To: T10 Technical Committee  
From: Rob Elliott, HP (elliott@hp.com)  
Date: 2 May 2007  
Subject: 07-091r2 SAS-2 SMP function support for SNW-3 phy capabilities

**Suggested changes to SAS-2**

Figure 127 — SNW-1, SNW-2, and Final-SNW

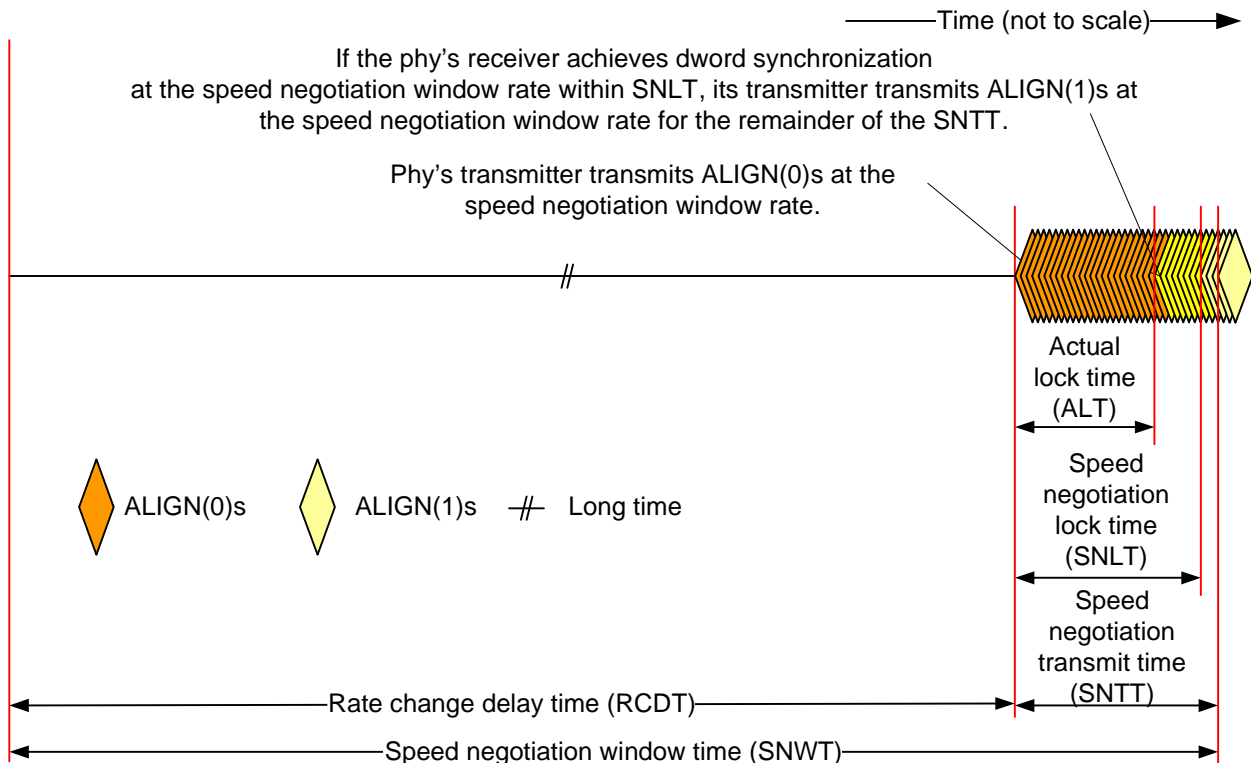
Figure 127 defines the ~~speed negotiation window~~SNW format for SNW-1, SNW-2, and Final-SNW, including:

- speed negotiation window time (SNWT);
- rate change delay time (RCDT);
- speed negotiation transmit time (SNTT);
- speed negotiation lock time (SNLT); and
- actual lock time (ALT).

**Figure 128 — SNW-3**

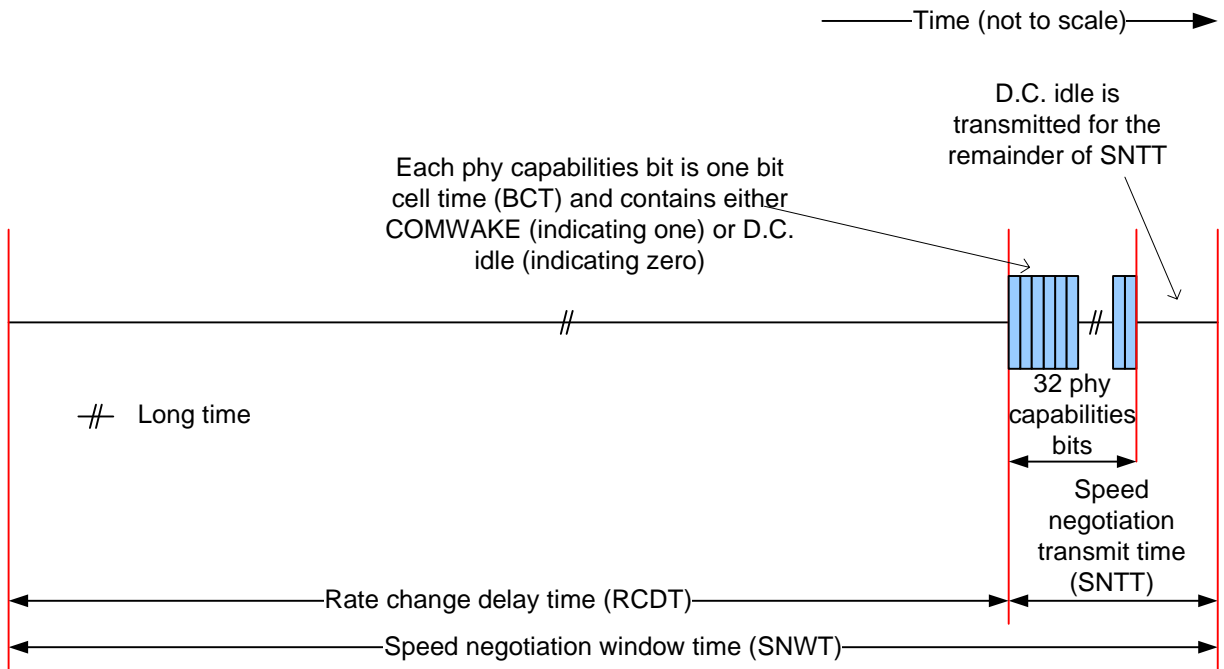
Figure 128 defines SNW-3, including:

- ~~speed negotiation window~~ SNW time (SNWT);
- ~~speed negotiation window~~ SNW rate of 1,5 Gbps;
- rate change delay time (RCDT); and
- speed negotiation transmit time (SNTT).
